COMMANDANT NOTICE 16500

Subj: CH-1 TO ALTERNATING CURRENT AIDS TO NAVIGATION SERVICING  
GUIDE, COMDTINST M16500.17

CH-1 TO ALTERNATING CURRENT AIDS TO NAVIGATION SERVICING GUIDE,  
COMDTINST M16500.17

Figure 3-3 (without heat switch)

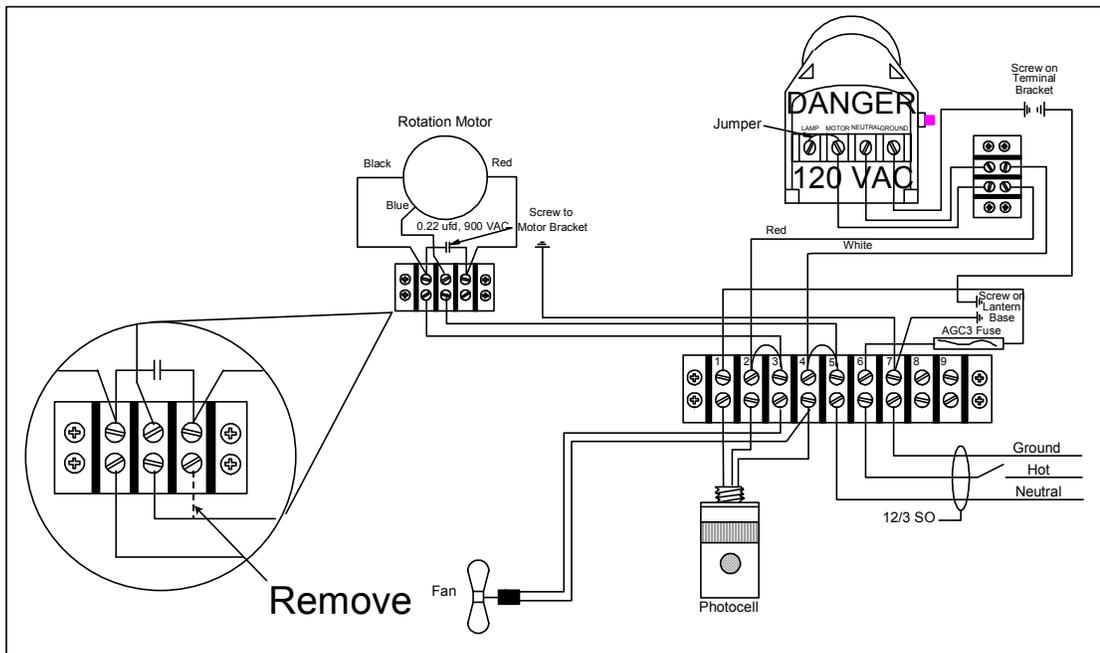
7. Figure 3-3, cross out the jumper on the small terminal strip connected to the rotation motor, and add the notation “(without heat switch)”, as shown below:
